1 - Revised Open Space Plan – 12-4-14

2 - Viewshed Protection Area

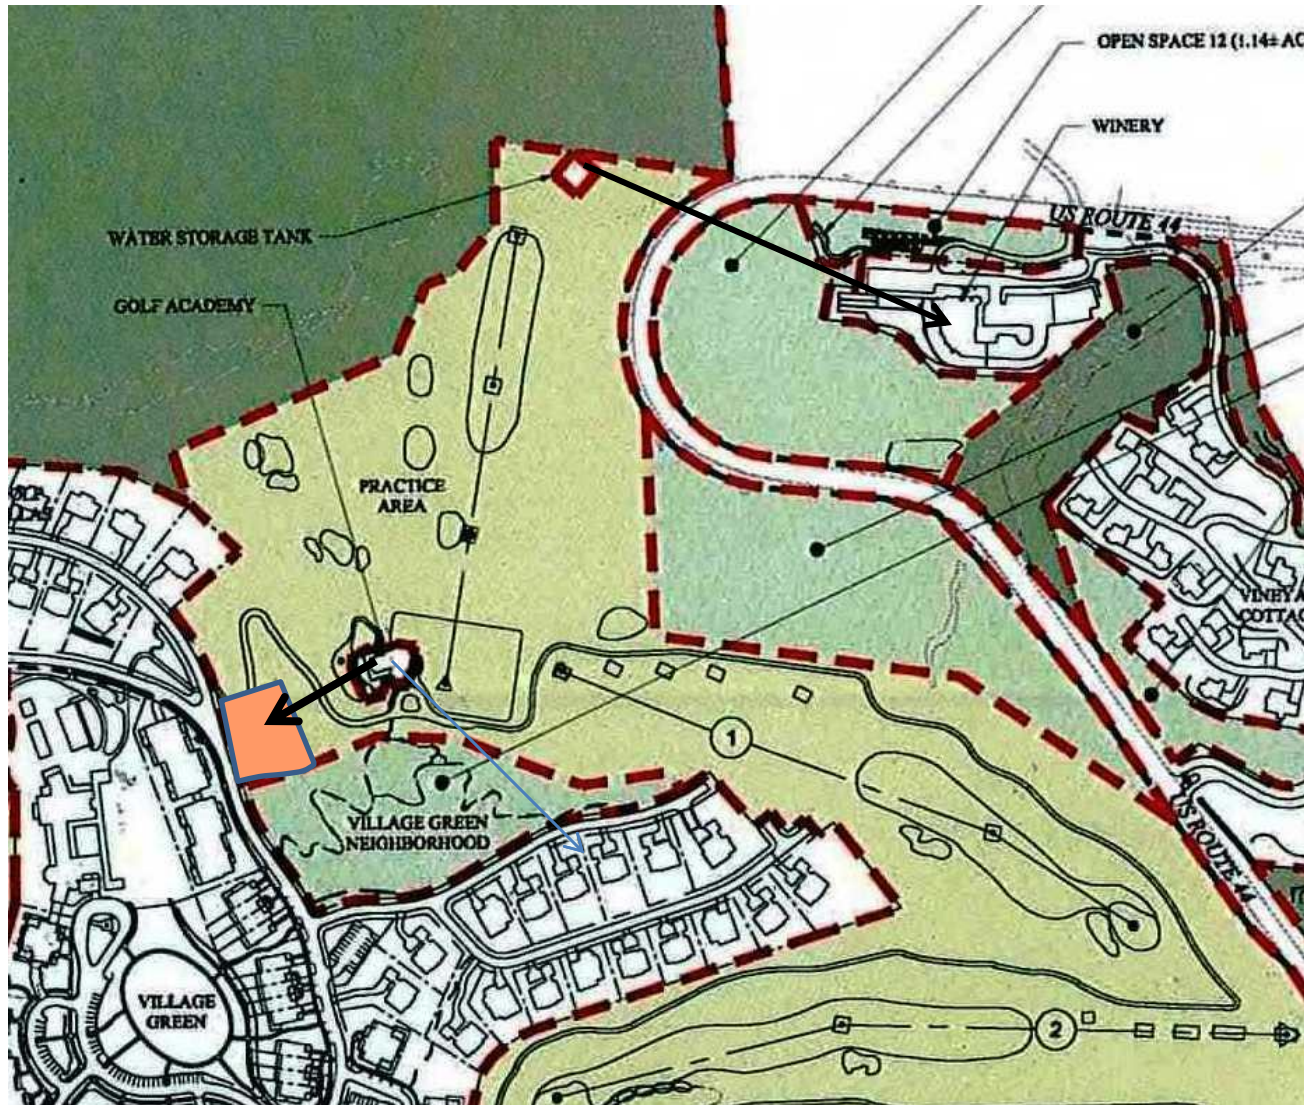
Recommended Viewshed Protection Areas

3 - Golf Academy & Water Tank

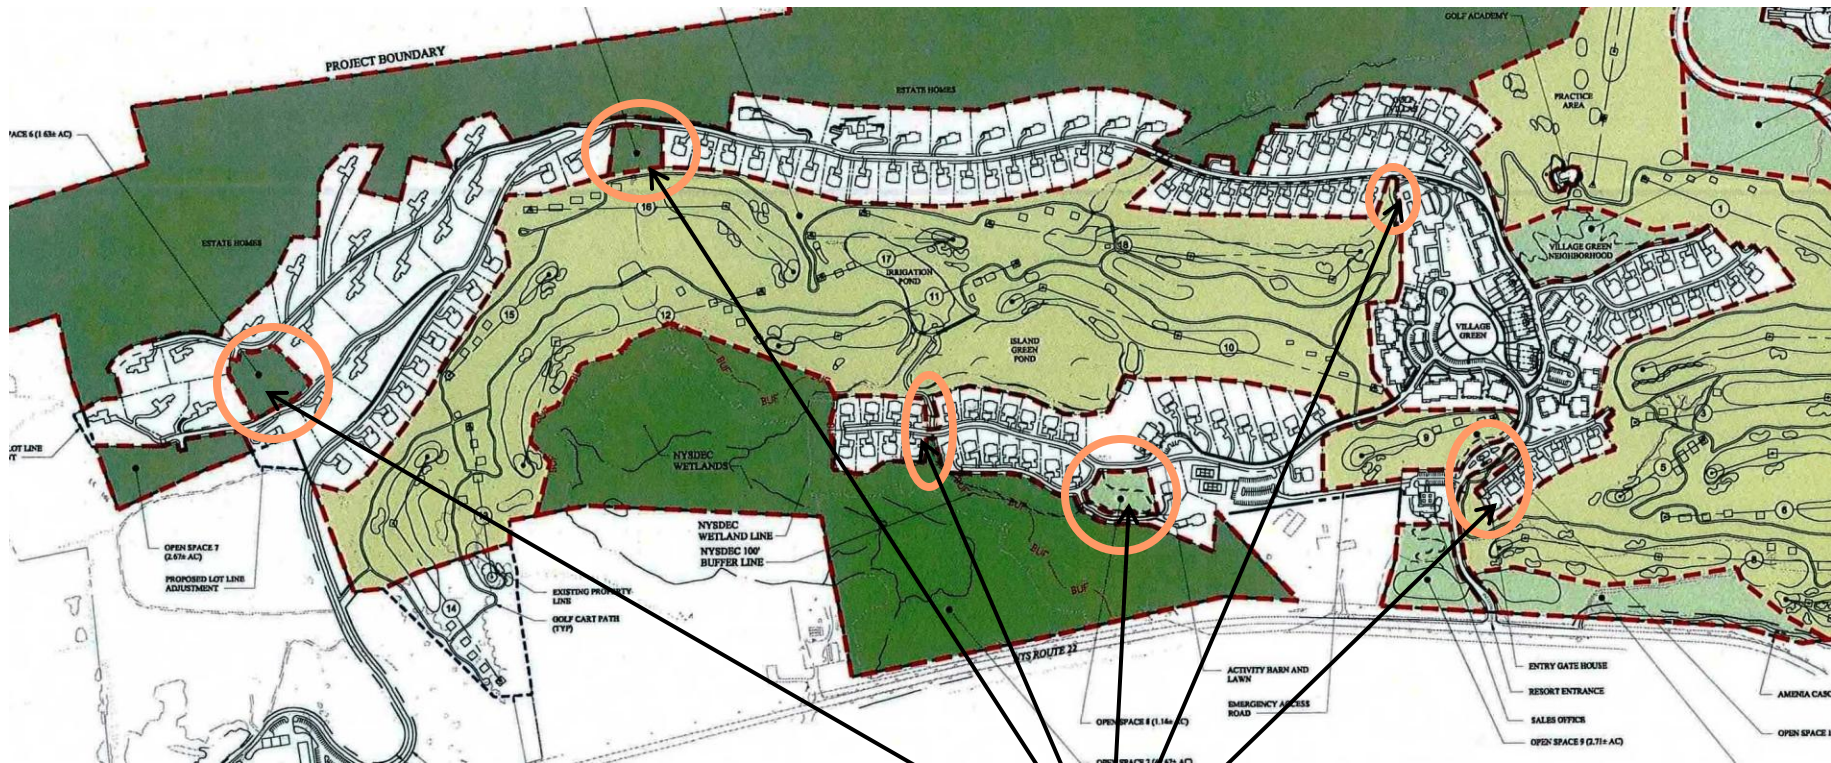
Relocate
Golf
Academy
out of
Viewshed

Relocate
Water
Tank out
of
Viewshed

5 - Random Disconnected Areas

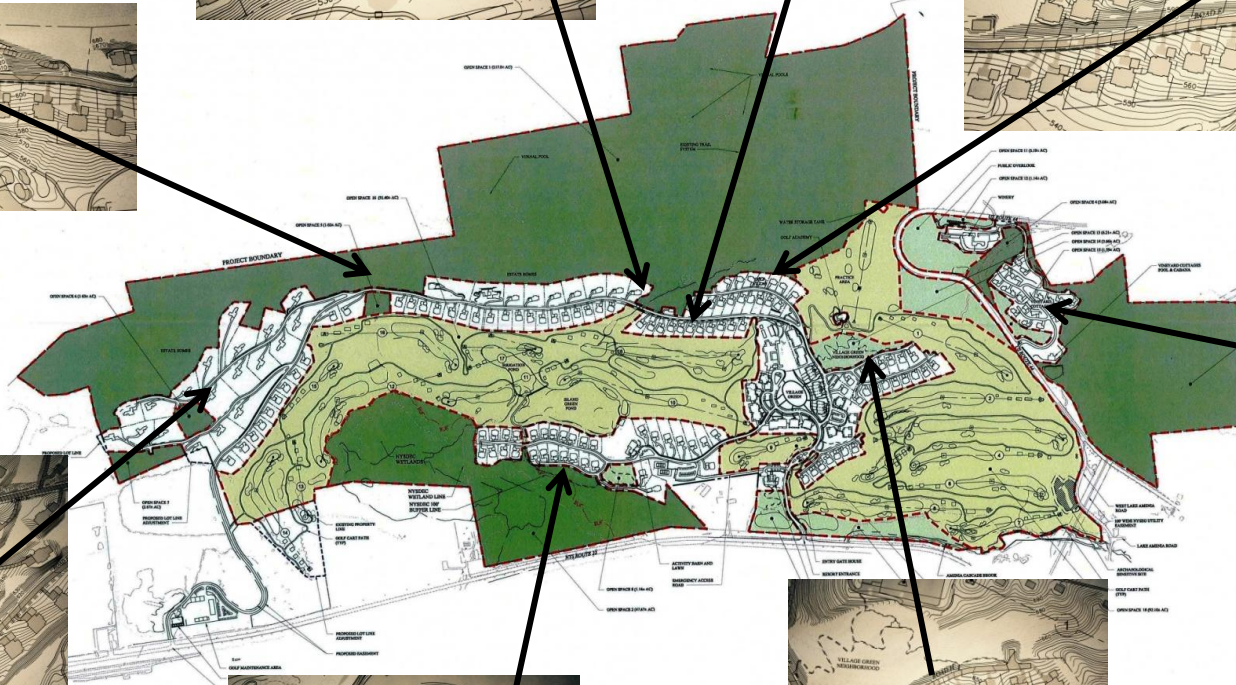
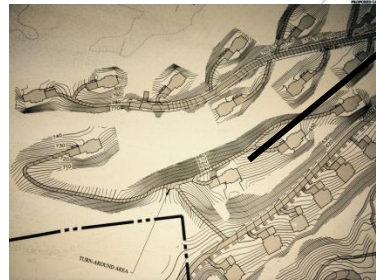
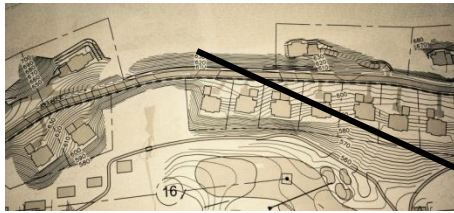
Eliminated random disconnected areas of Open Space

Ideally the Open Space should have nice straight lines as boundaries

7 - Vineyard Cottages

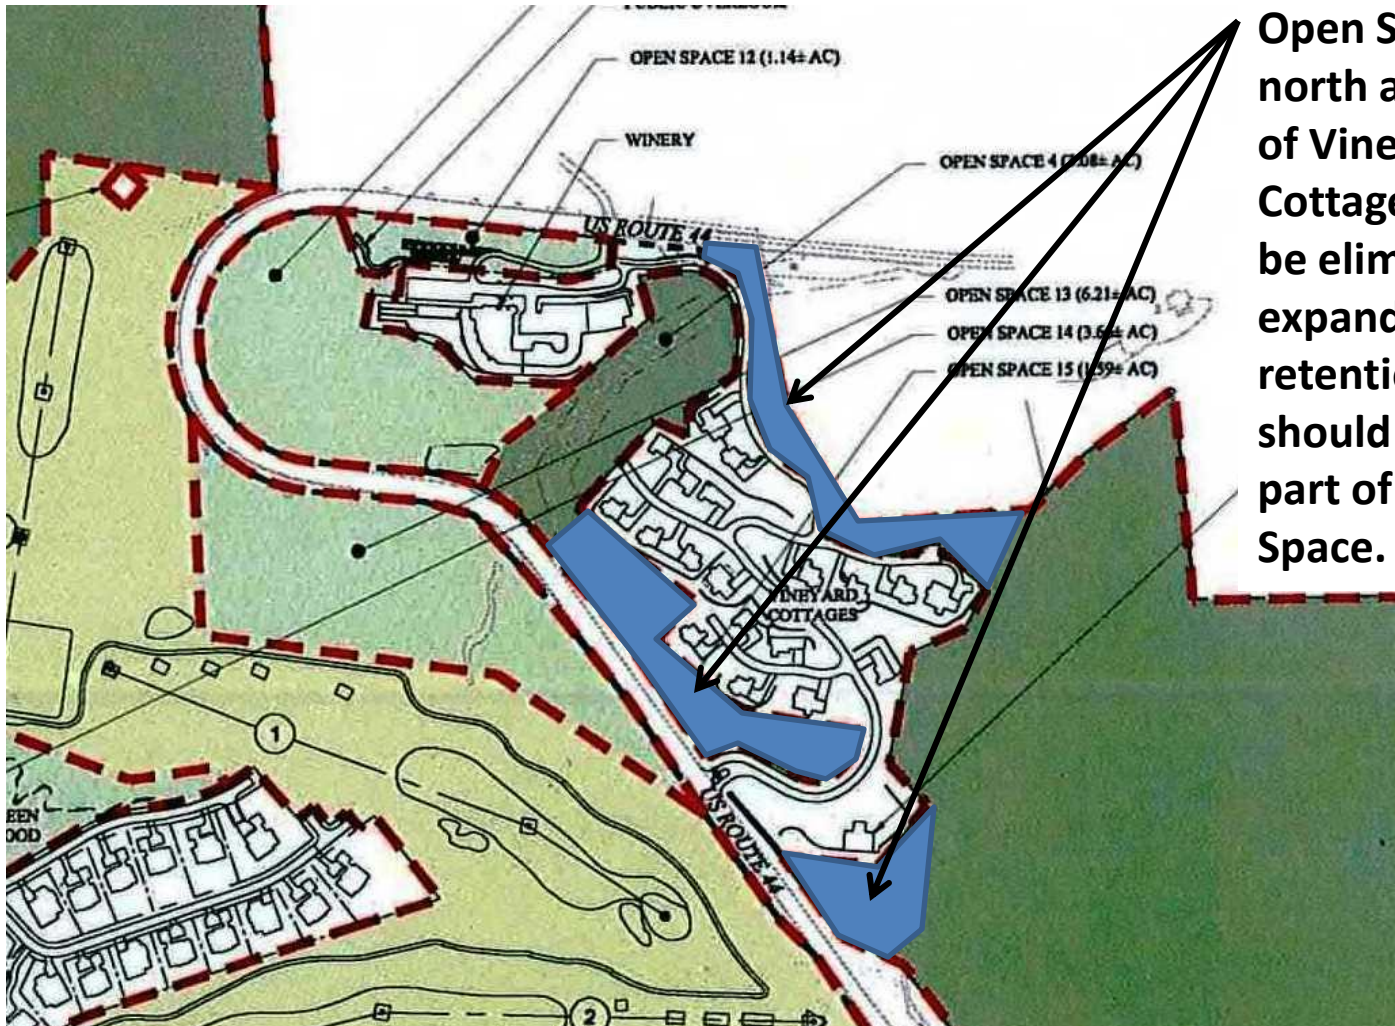
Open Space to north and south of Vineyard Cottages should be eliminated or expanded; retention pond should not be part of Open Space.
